**ADJUDICATORY APPEAL OF NMOCD DISTRICT II
REJECTION OF "APPLICATION FOR ADMINISTRATIVE
APPROVAL OF A RELEASE NOTIFICATION
AND CORRECTIVE ACTION (C-141)
FOR INCIDENT ID #NAPP2206346222"
Application ID: 114703**

CASE NO. 23646

SUPPLEMENTAL FILING TO THE APPEAL BY LONGFELLOW ENERGY, LP

Correction of Information Request by Jerry D. Worsham

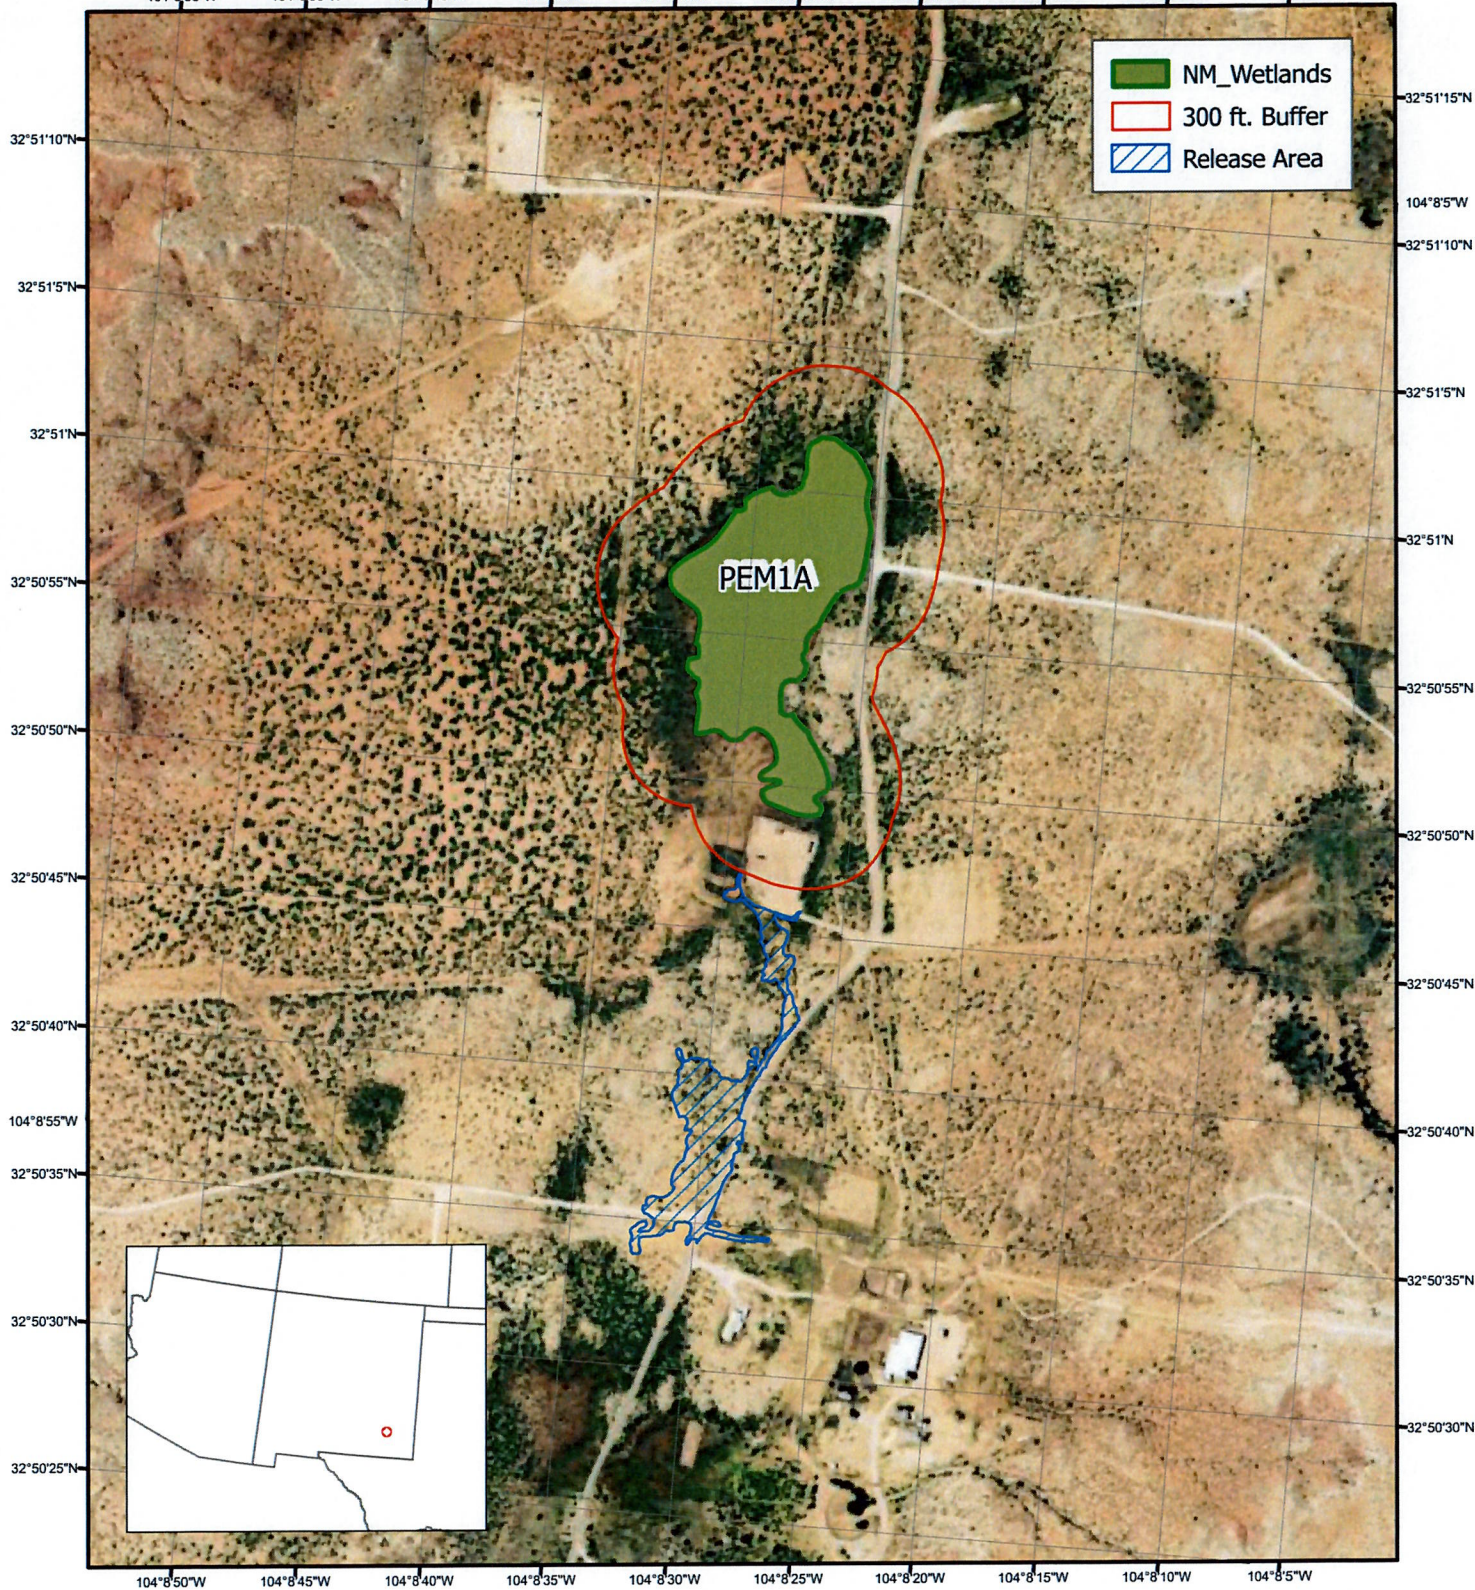
FWS Personnel: Rusty Griffin	Approved or Denied: Approved	Date: 6/13/2023
Justification for Correction Approval/Denial: Wetland determination data submitted and a re-examination of higher resolution imagery determined the wetland polygon boundary to be larger than the wetland was on the ground.

I have attached a map depicting the edited wetland polygon reflecting the on-site information you provided. This correction has been made in our local database. The public facing data seen on the Wetlands Mapper is updated bi-annually with the next update scheduled for October 1, 2023. On or about that date the edits to this particular wetland will be visible and active on the public mapper. If you need the actual data, I can provide a shapefile or geodatabase. Just let me know.
